CITY OF PLATTSBURGH
DPW & HEO BUILDING HEATING SYSTEMS

ADDENDUM NUMBER 1

1.01 DATE: July 8th, 2021

1.03 PROJECT NUMBER: 21031

B1 HOT WATER UNIT HEATER PIPING SCHEMATIC
6001 N.T.S.

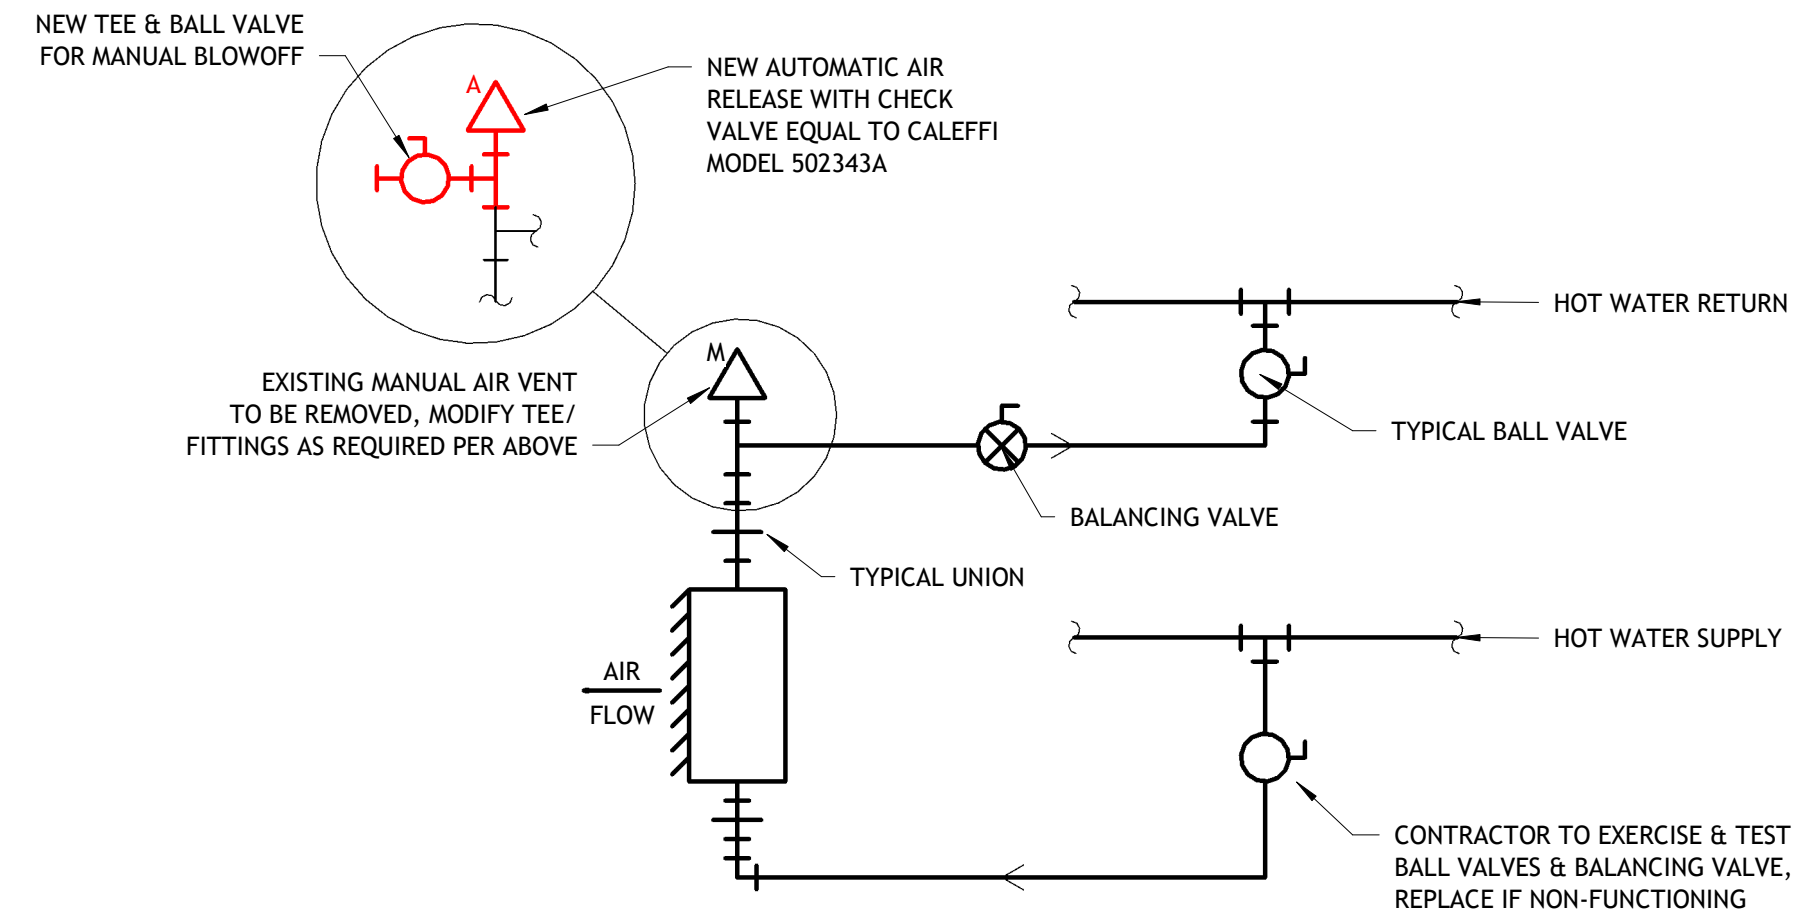
- D. **REPLACE** – Drawing G001 General notes: The attached drawing replaces the original G001 and now includes a detail to revise and replace the labels on drawings M101, M102, and M110 regarding the scope of work for replacement of the air vents at each existing unit heater assembly.

Answer – The proposed air release replacement at each unit heater was indicated to be manual air releases on the project drawings, however per the attached G001 drawing and the added schematic, the new air releases shall be automatic with new ball valve blowoff. All unit heaters are to remain.
